COUNCIL ASSESSMENT REPORT

Panel Reference	PPSSNH-70
DA Number	MOD2019/0214
LGA	City of Ryde
Approved Development	Construction of a mixed use development comprising a part 6 / part 27 storey building to accommodate 216 residential apartments, retail tenancies, a child care centre and a multi storey car park for 242 vehicles.
Proposed Modification	Section 4.55(2) to realign stormwater drainage infrastructure and amend conditions of consent relating to bushfire planning.
Street Address	112 Talavera Road, Macquarie Park
Applicant/Owner	Owner: Karimbla Properties (No. 52) Pty Ltd / Macquarie University Applicant: Karimbla Constructions Services (NSW) Pty Ltd
Date of MOD lodgement	28 October 2019
Number of Submissions	No submissions received objecting to the development
Recommendation	Approval
Regional Development Criteria (Schedule 7 of the SEPP (State and Regional Development) 2011	Modification application for regionally significant development under Section 4.55(2) of the EP&A Act.

This report considers a Section 4.55(2) application under the *Environmental Planning and Assessment Act, 1979* (EP&A Act) to modify the approved development at 112 Talavera Road, Macquarie Park.

This mo

Figure 4: Approved location of stormwater infrastructure (under LDA2018/0269)

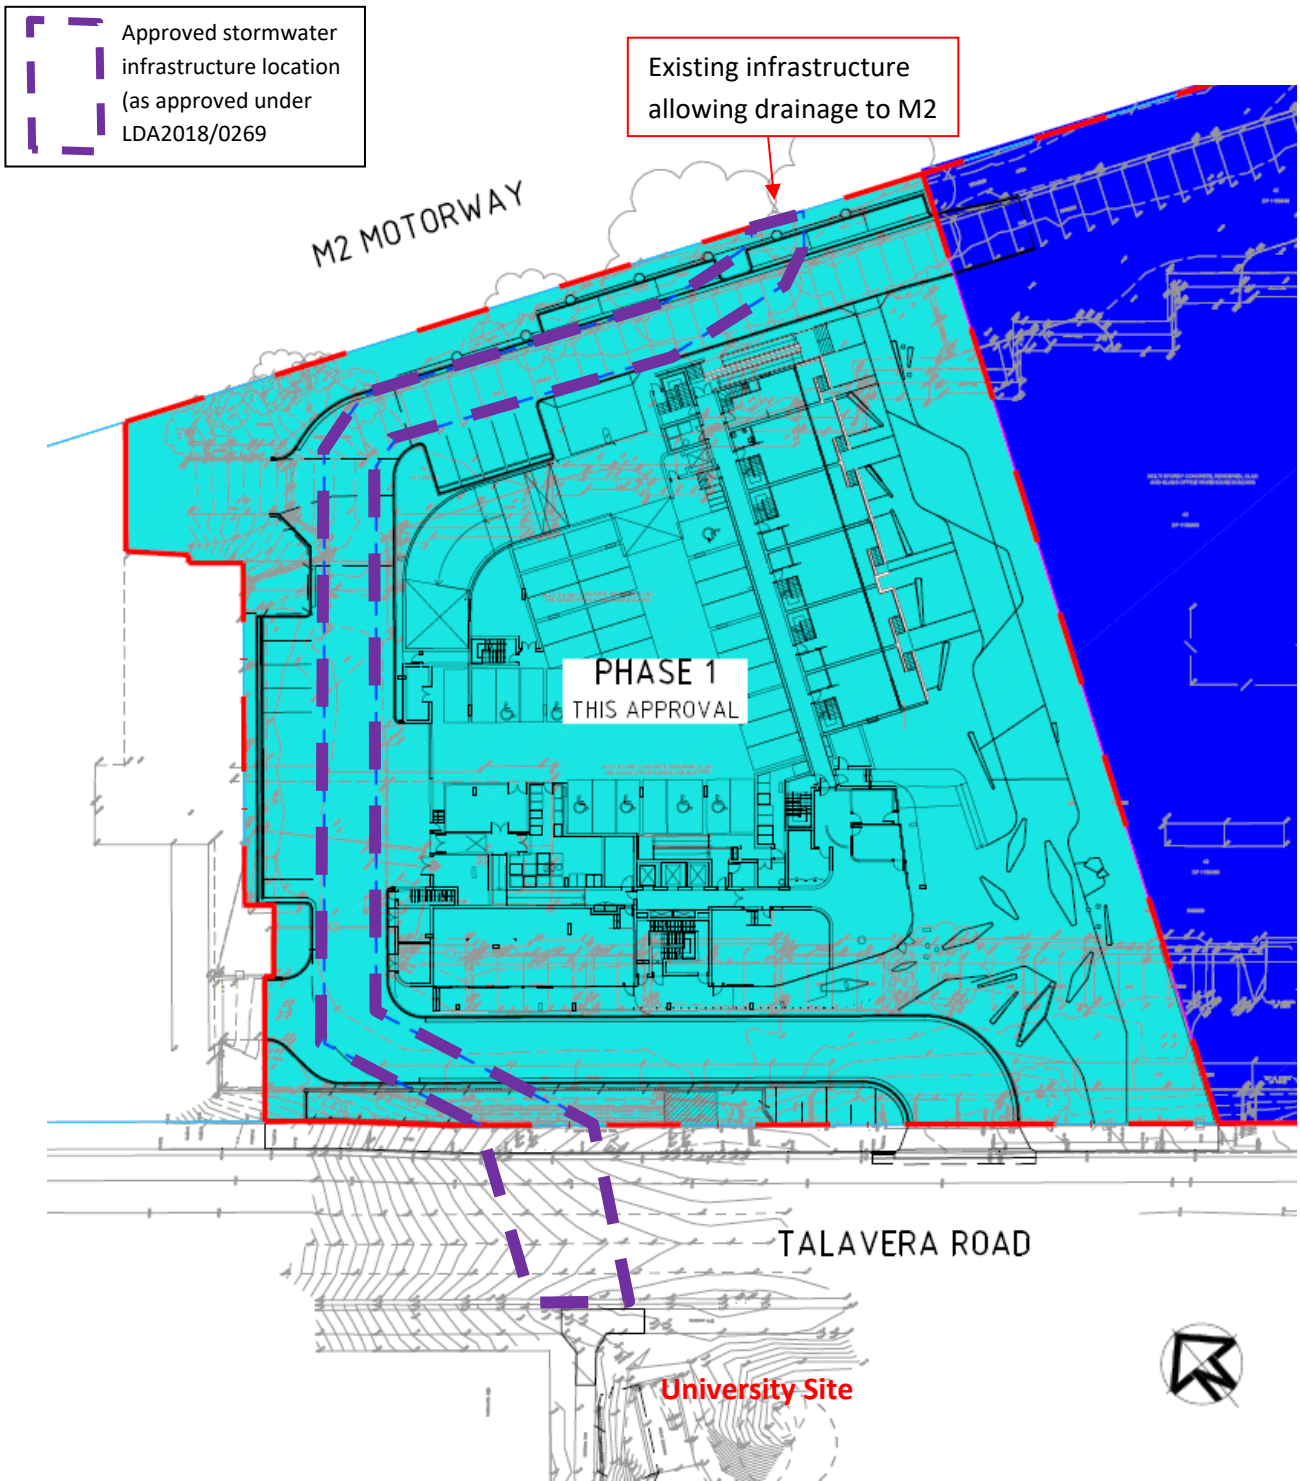
As mentioned earlier in the report, the original approval involved the stormwater infrastructure being directed around the western side of the site. The location of the approved stormwater infrastructure is illustrated in **Figure 4** above.

Figure 5: Proposed stormwater design showing realigned trunk drainage

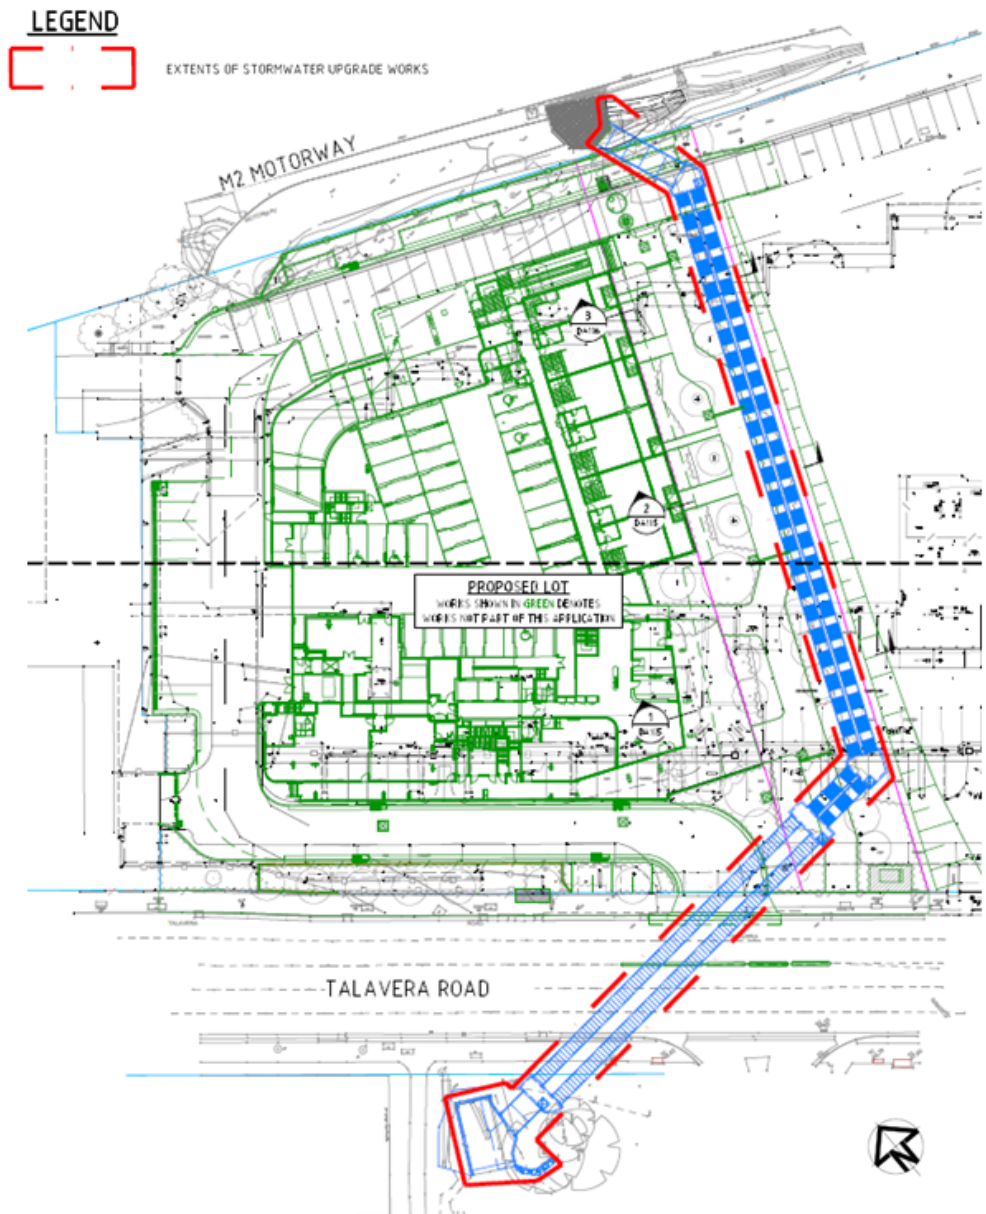
The proposal seeks to realign the approved stormwater infrastructure from the western side of the site to the eastern side of the site. The modification to the approved drainage design is show in **Figure 5** below.

The modification of the stormwater will involve realigning the culvert within the Macquarie University site and aligning the trunk drainage under Talavera Road and along the eastern boundary of the Stage 1 site.

Despite the revised stormwater plan (see **Figure 5** above) stating that there are no amendments to the plan with the exception of the trunk drainage alignment, the plans include an amendment to the fill required along the northern boundary. The applicant has identified that further enforcement is required for the parking spaces along the boundary adjoining the M2 Motorway, as shown in **Figures 6** and **7** below. As such, a retaining wall has been included in the stormwater plans.

Subject to the modification of a number of conditions, Council's City Works (Drainage) section have found the revised proposal to be satisfactory (see amended **Conditions 82, 117, 120, 121, 170, 224, 226, 232 and 233**).

Figure 7: Extract of amended stormwater plans with new retaining wall highlighted in yellow

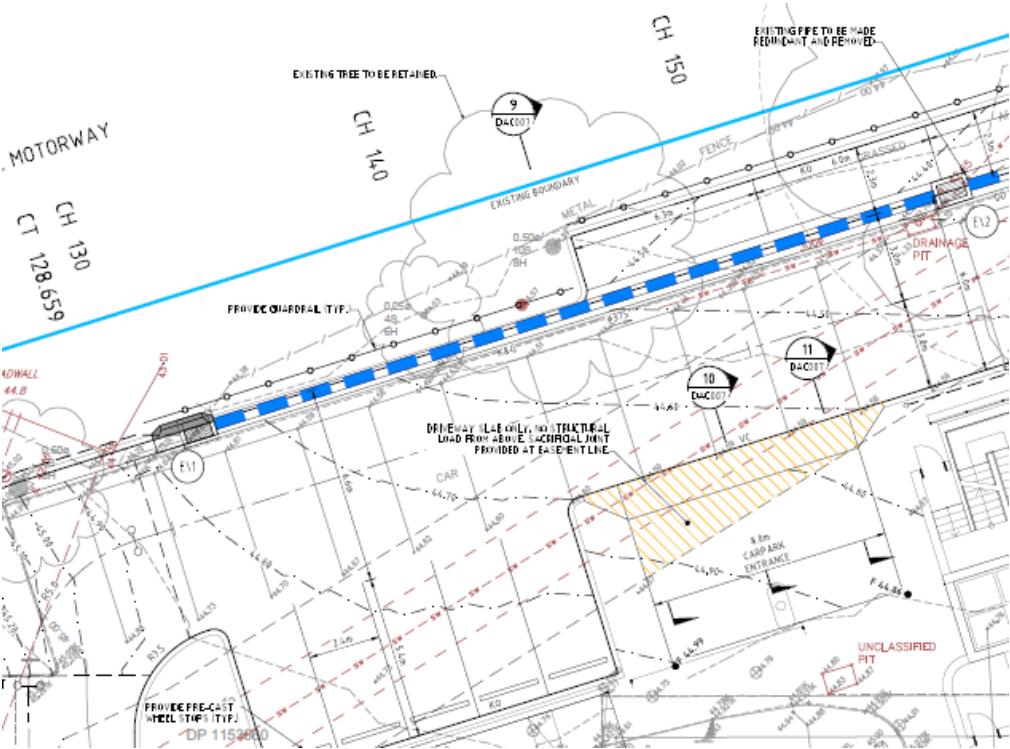
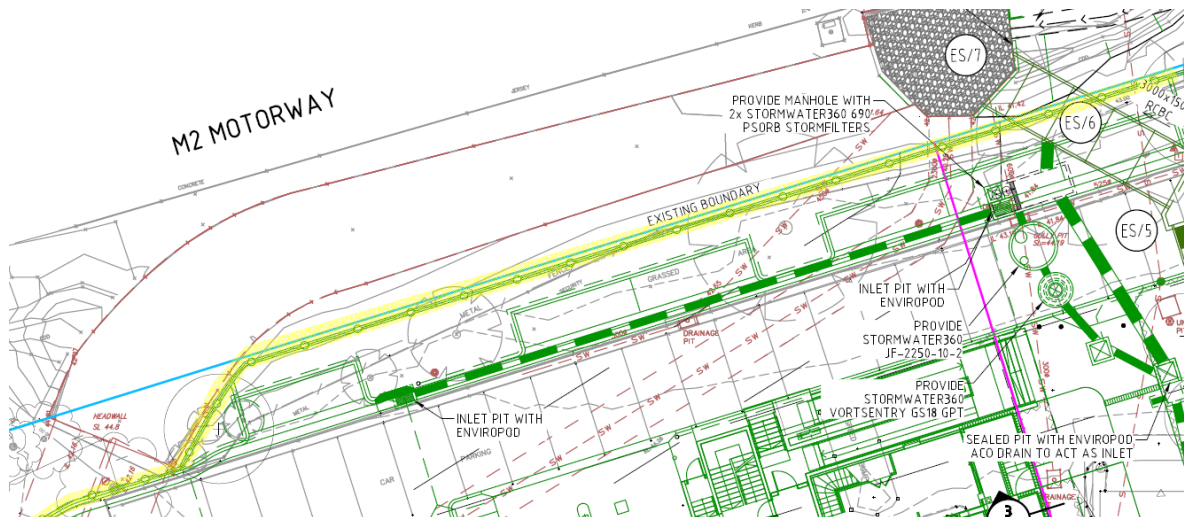
The height of this retaining wall is approximately 2 metres, and the wall will essentially be located behind the barrier within the M2 land, preventing it from having an adverse visual impact as viewed from the M2 Motorway.

The modification does not seek to vary the parking arrangement. Council's assessing officer and landscape architect have highlighted that the stormwater plan DAC111 appears to depict a retaining wall adjacent to the M2 motorway boundary. It appears the purpose of the retaining wall is to support the designated parking bays within this area. The ramifications of these works may result in the loss of the trees within the vicinity of this area and thus a modified landscaping condition may be required to replace these trees.

- Amend Condition 82 to reflect changes in stormwater design;
- Delete Condition 100(c) in relation to the retention of Tree 12;
- Addition of Condition 100(e) to reflect new retaining wall on northern boundary;

Figure 9: Flood Risk Map (City of Ryde 2017)

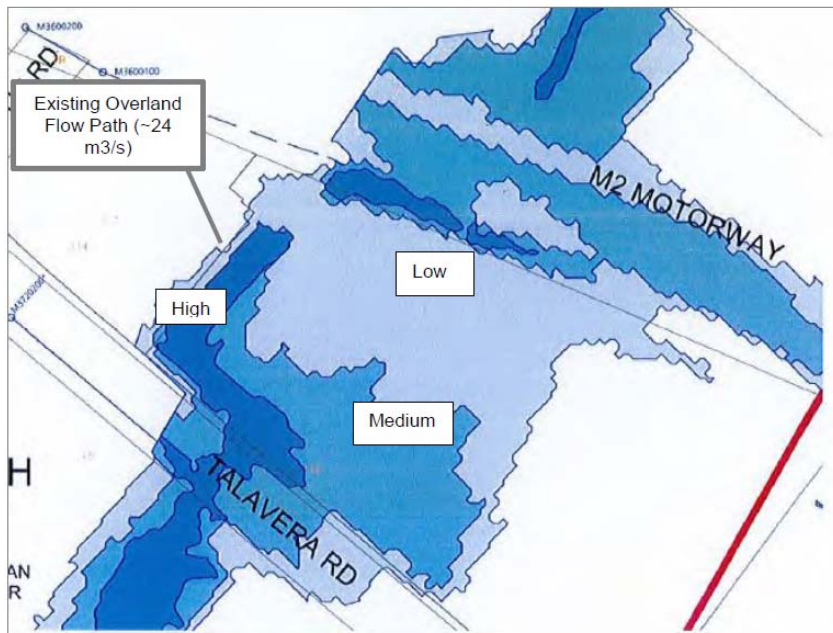
The site is subject to an overland flow path, as illustrated in **Figure 9** below. This flow path travels from upstream properties at Macquarie Park, across the site and the M2, discharging in the Lane Cove National Park. Stormwater flows are ultimately directed into Lane Cove River to the north-west.

The applicant has provided a Flood Impact Assessment with the subject modification application explaining that the previously approved Flood Impact Report did not consider that flood mitigation works that had already been completed along University Creek by Macquarie University. As a consequence, the revised flood assessment has been updated to include these works, and has led to a new stormwater drainage system, whereby the alignment of the stormwater culvert on the western portion of the site in the approved development is to be diverted to the eastern portion of the site to better orient the drainage system with the footprint of the approved buildings and associated infrastructure.

Figure 14: Location of trees being retained (in green) and removed (in purple) on University Site

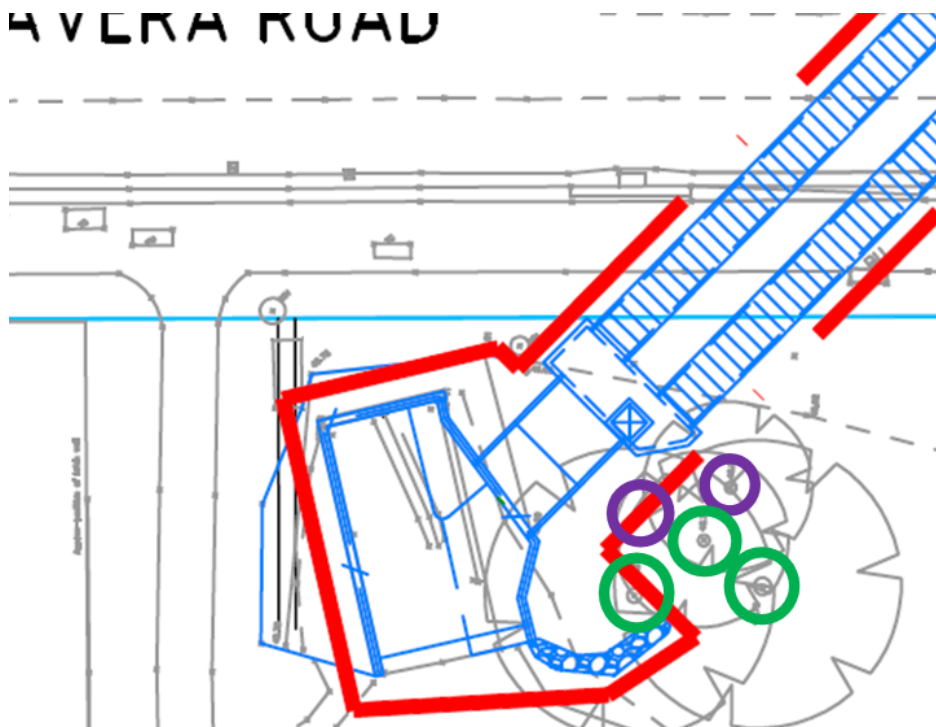
Trees C and E do not form part of the Sydney Blue Gum Ecologically Endangered Community (EEC) and therefore, do not require assessment under the *Biodiversity Conservation Act 2016*. Furthermore, a condition of consent (see **Condition 131(b)**) has been included that requires compensatory planting within 192 Balaclava Road of four (4) Sydney Blue Gum trees.

Trees A, B, C, D and E are Eucalyptus saligna (Sydney Blue Gum) and are located on the southern side of Talavera Road in Macquarie University land and impacted by the proposed new drainage works. Trees A, B and D can be retained, trees C and E will need to be removed. I agree with these recommendations subject to replacement planting.

- The two trees (Tree C and E) on the University Site do not form part of the Sydney Blue Gum Endangered Ecological Community, and a condition of consent has been imposed (see **Condition 131(b)**) that four (4) compensatory Sydney Blue Gum trees are to be planted in this area.
- The approved landscape plan provides sufficient planting within the subject site to allow for the removal of the eight (8) additional trees being removed within the subject site.
